**METROPOLITAN GOVERNMENT OF NASHVILLE AND DAVIDSON COUNTY**

**STAFF RECOMMENDATION**  
**1807 Blair Boulevard**  
**October 21, 2015**

**Application:** New construction- addition and detached accessory dwelling unit; Partial demolition

**AS1.0**

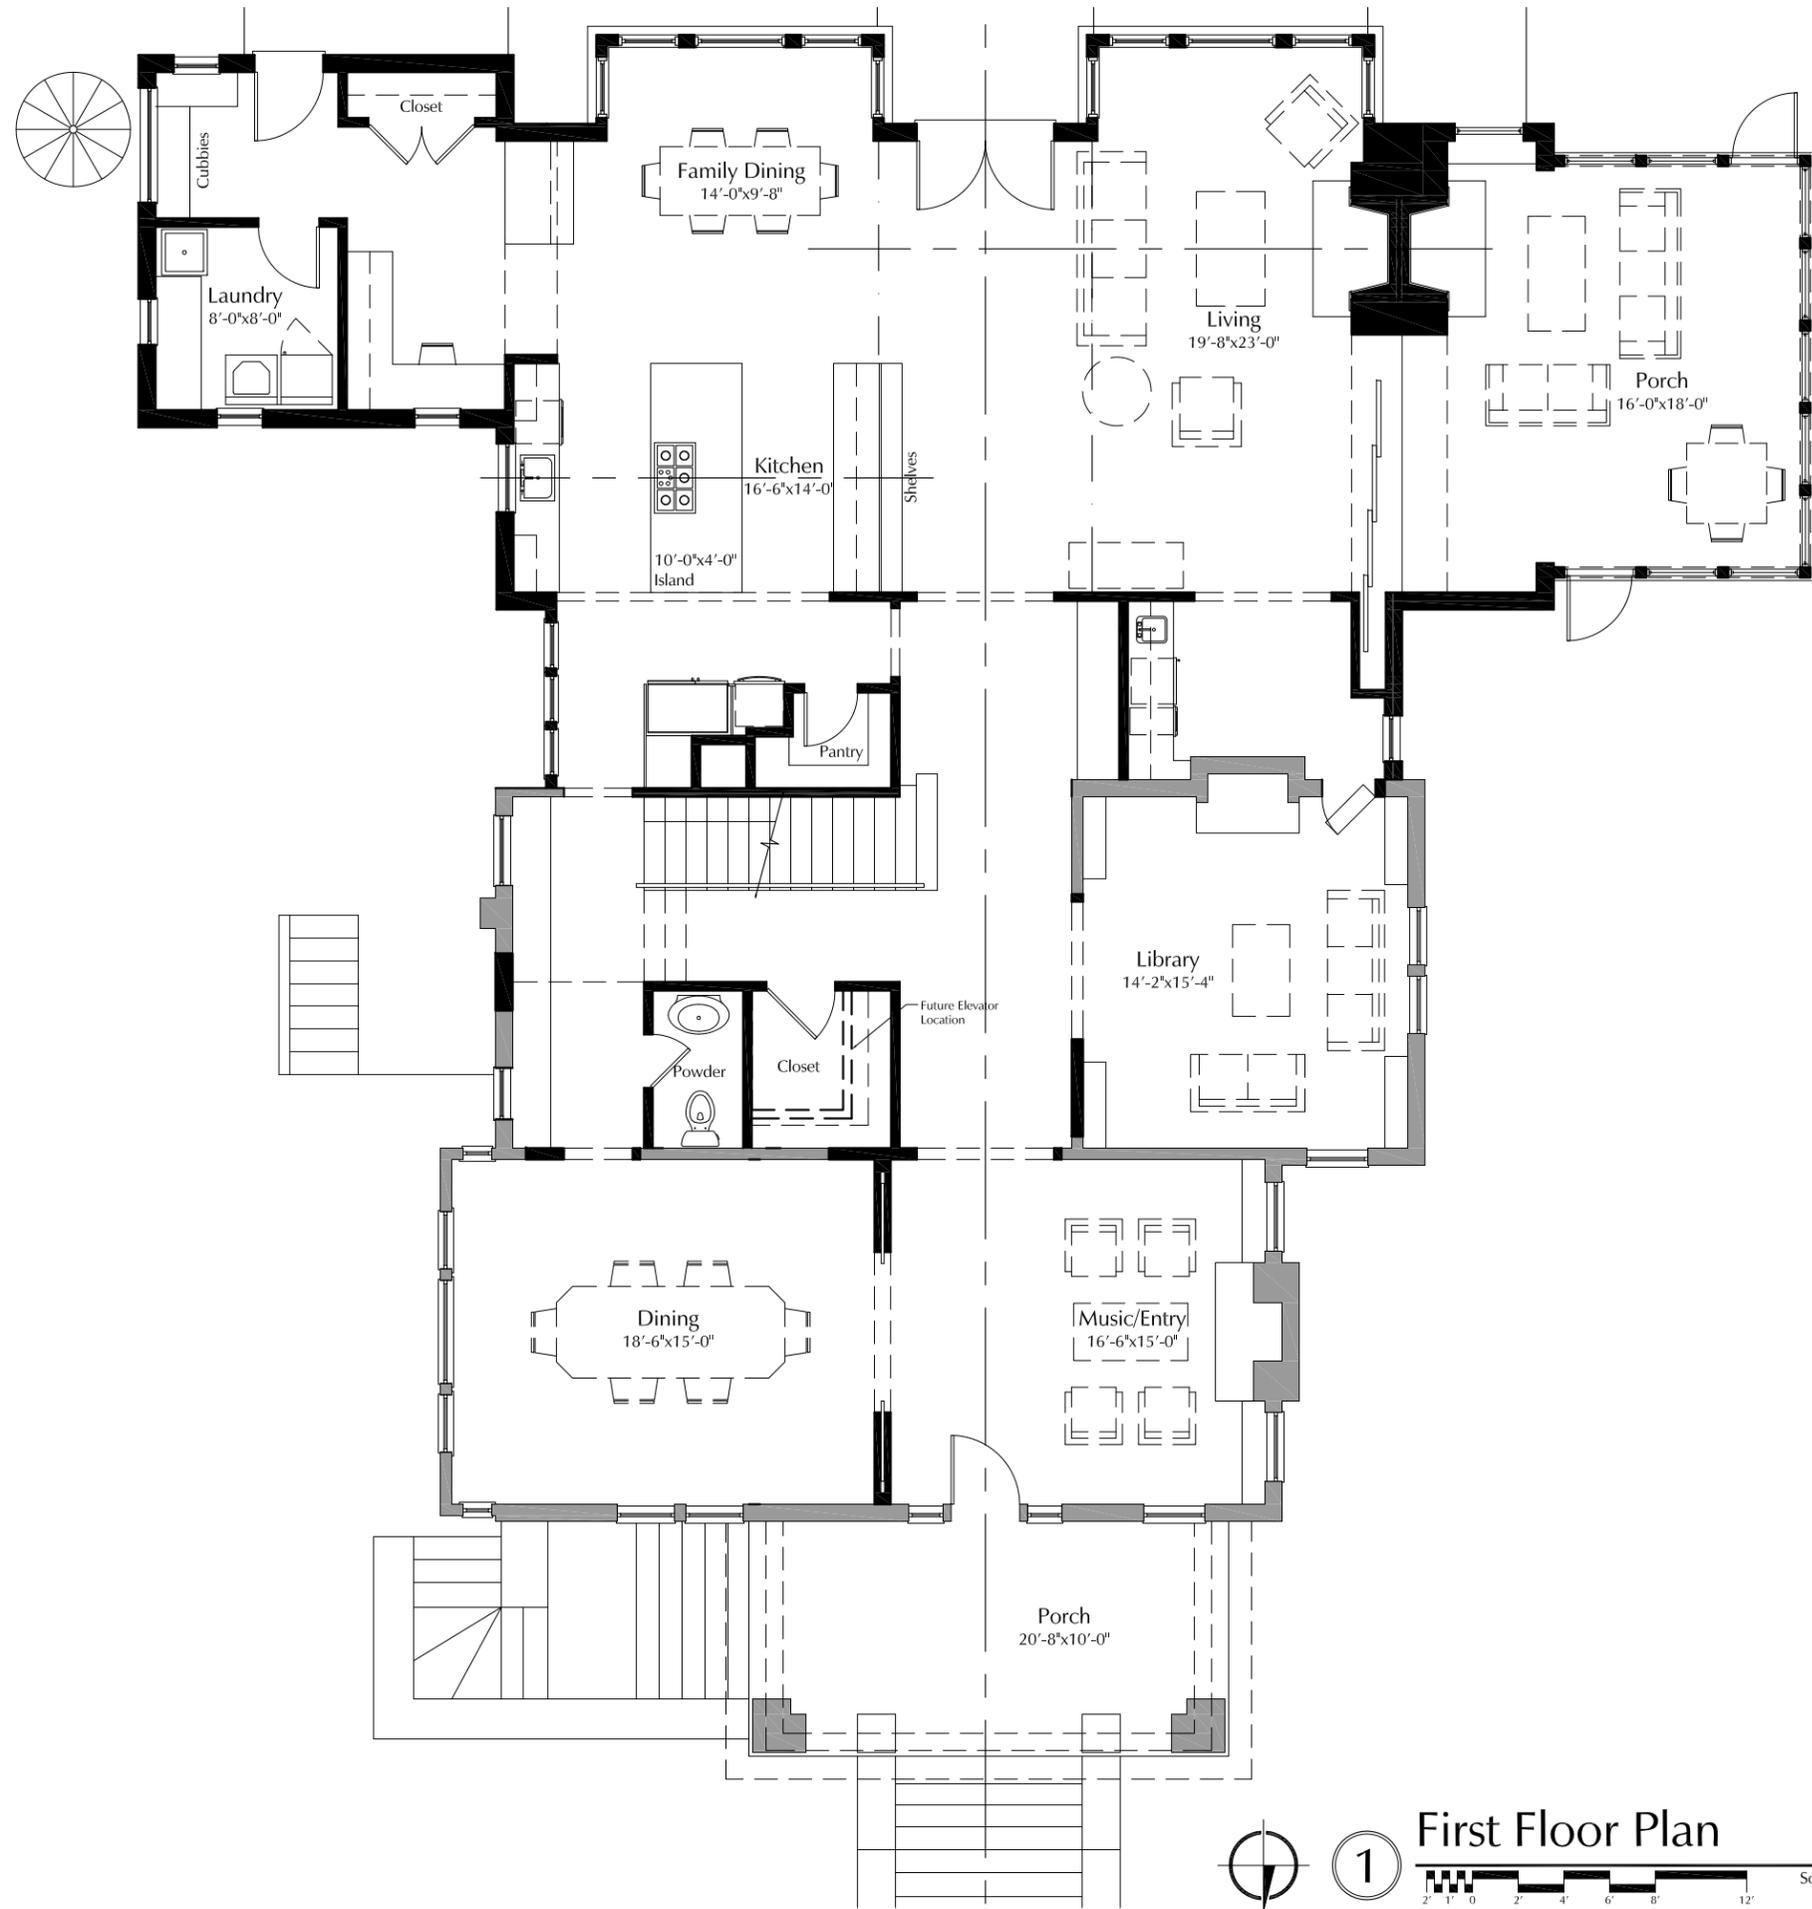
Setback: The setbacks will be nineteen feet, seven inches (19'7") on the left side, and thirty-seven feet, three inches (37'3") on the right. The rear wall of the addition will be fifty-six feet, five inches (56'5") from the rear property line. The project meets bulk zoning requirements and section II.B.i.c for setbacks.

**A2.1**

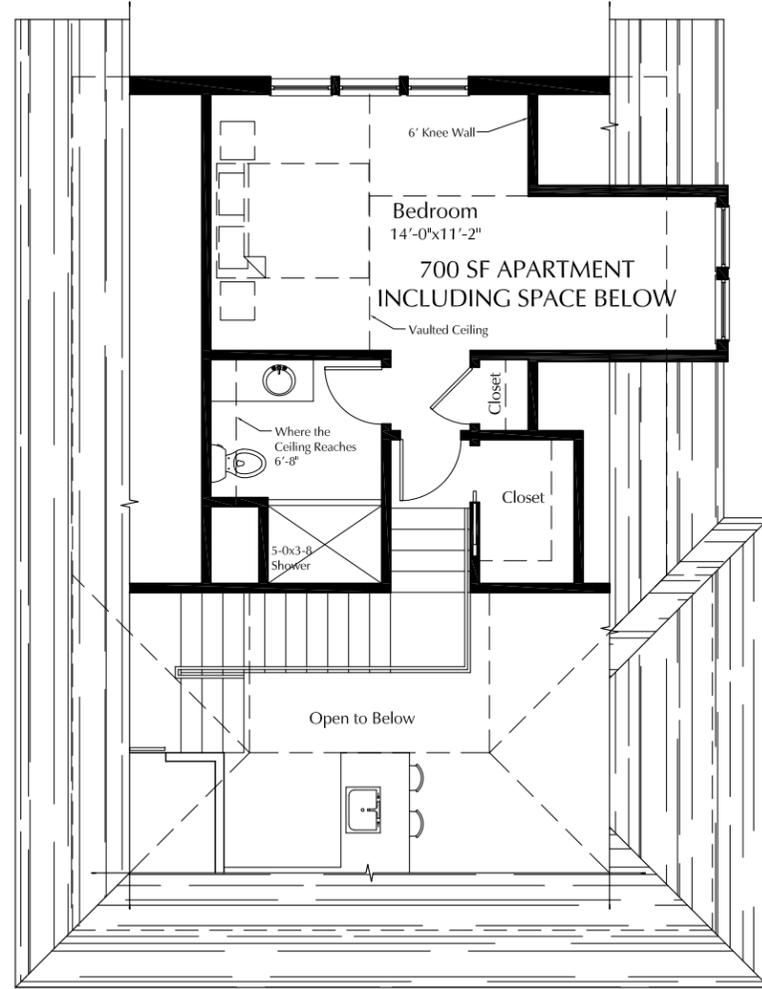
Materials: The addition will be brick to match the historic house with a parged foundation. Trim will be wood. The roof for most of the addition will be dimensional asphalt shingles with a metal roof for the new porch addition on the left side of the house. The windows will be Marvin clad or Integrity Ultrex/wood windows, which have been approved in the past. Staff recommends administrative approval of the final window design. Information on materials for windows, doors, roof color and the screening for the porch has not been provided. Staff recommends including a condition that staff approve the final window, door, roof color and screening selections prior to purchase and installation. The new chimney will be finished with brick. With the condition that staff approve the final selection of the windows, doors, roof color and screening, staff finds that the project meets section II.B.1.d.

Roof form: The addition will have a hipped roof, with a pitch of 7/12 complement the existing hipped pyramidal roof. The plan includes a set of two-story bay windows on the rear elevation. The roof form and pitch do not contrast with those of neighboring historic buildings, and are compatible with those of the house. The project meets section II.B.1.e.

Proportion and Rhythm of Openings: The windows on the proposed addition meet the historic proportion of openings, being generally twice as tall as they are wide. The rear elevation also includes two two-story bay windows. There are no large expanses of wall space without a window or door opening. Staff finds the project's proportion and rhythm of openings is consistent with Section II.B.1.g.

**Drawings:**  
 Garage First Floor Plan  
 Garage Second Floor Plan  
**Date:**  
 10.08.15

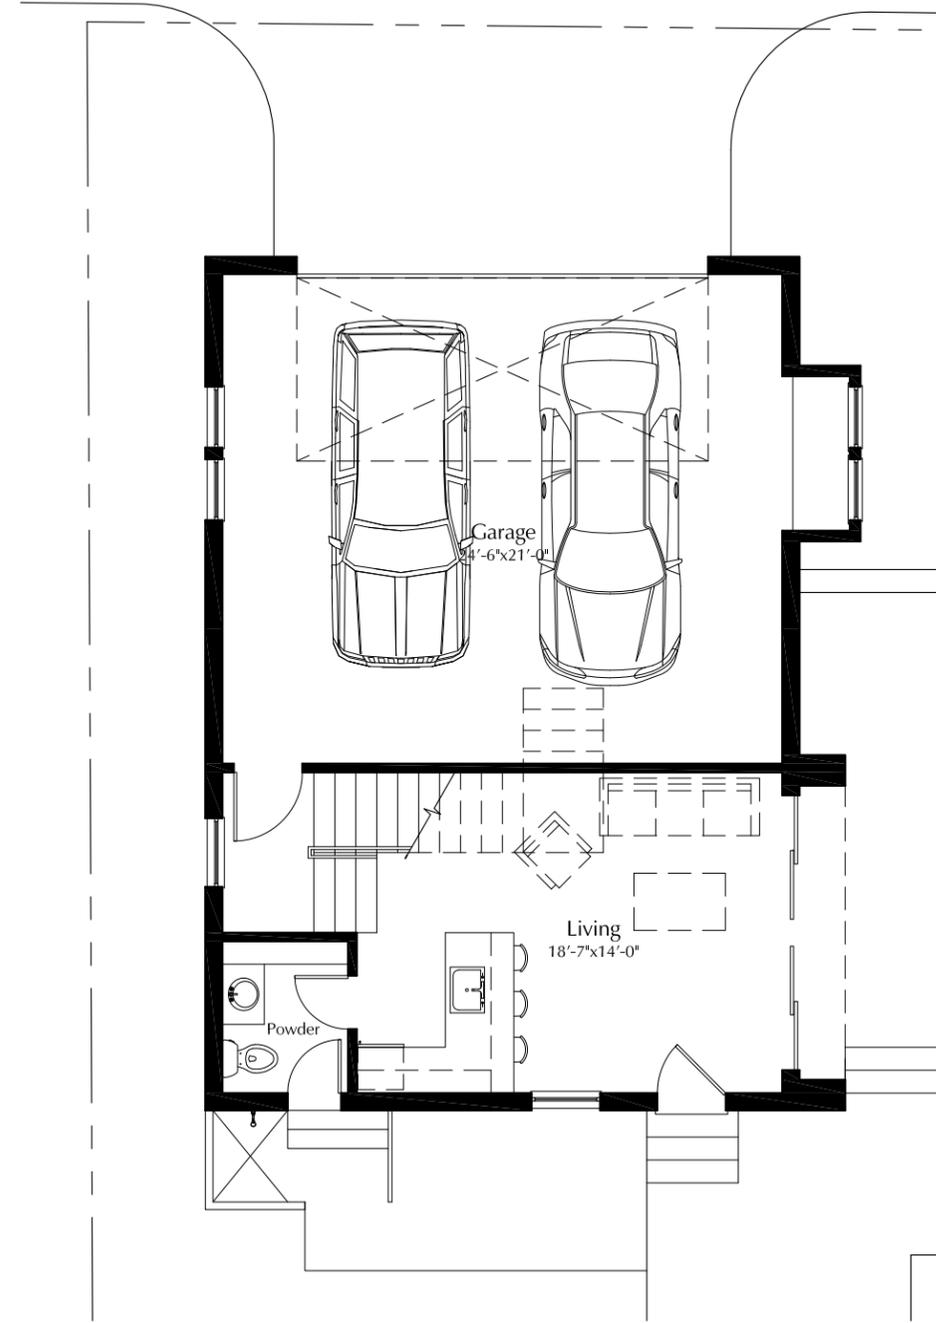
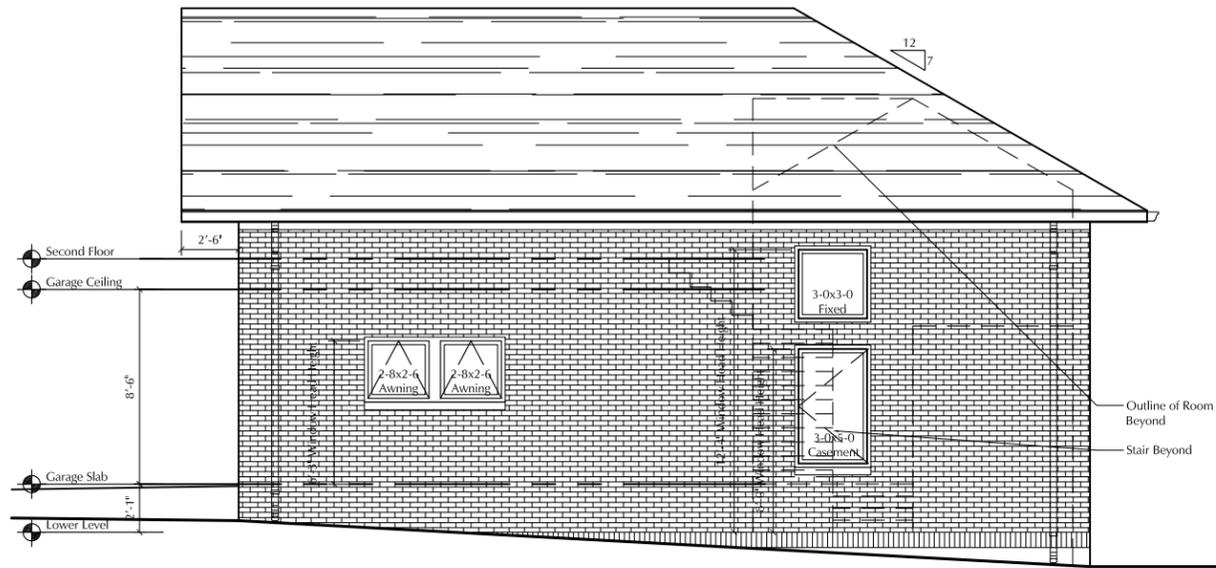
The lot is approximately twenty-two thousand one hundred square feet (22,100 SF). Because it exceeds ten thousand square feet (10,000 SF), the design guidelines allow for a footprint of up to a thousand square feet (1000 SF). The structure's footprint will be approximately nine hundred eighty-nine square feet (989 sq. ft.), under the maximum. By comparison, the primary structure has a proposed footprint of approximately three thousand, one hundred feet (3,100 sq. ft.). Staff therefore finds that the accessory structure is subordinate in size and does not exceed the height of the primary structure nor the maximum eave and ridge heights specified in the design guidelines.

④ Garage East Elevation  
 Scale: 1/8"=1'-0"

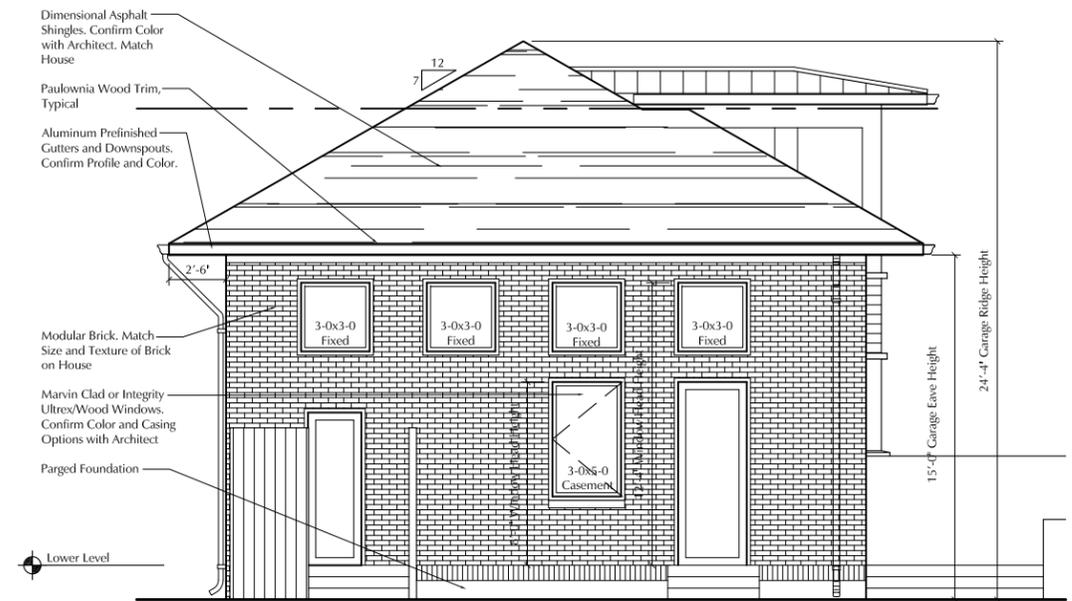
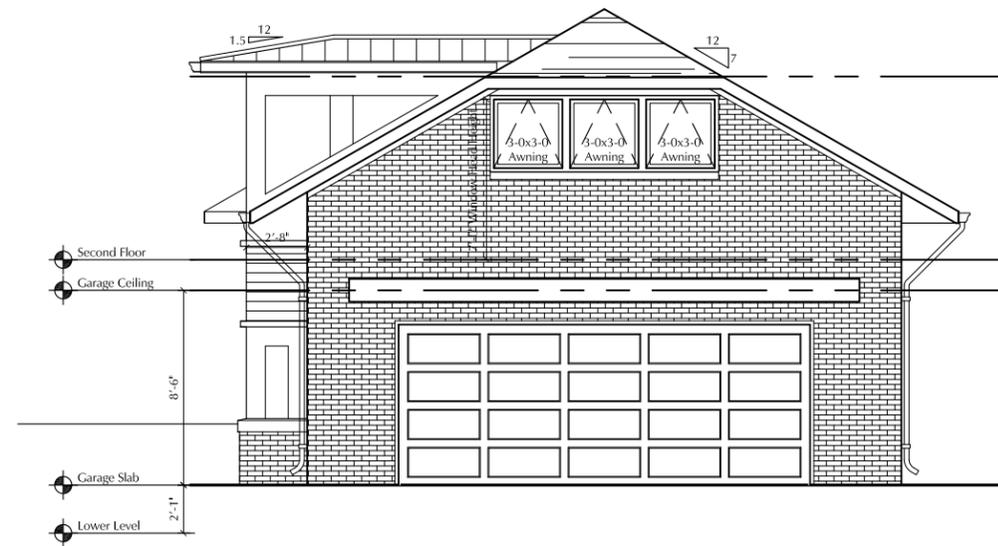
Height, Scale: The two-story DADU is proposed to have a ridge height of approximately twenty-four feet, four inches (24'4") which includes the foundation which is a maximum of ten inches (10") tall and varies with the grade. The eave height will be approximately fifteen feet (15') above grade. In comparison, the average eave height of the principle dwelling is approximately eighteen feet (18') above grade and the ridge height is taller

Materials, Roof Form: The roof will have a 7:12 gable matching the existing building with a two story bay window on the right side façade, similar to those proposed on the rear addition. The exterior materials of the DADU include a brick, a parged foundation and a dimensional asphalt shingle roof. These materials match the historic building.
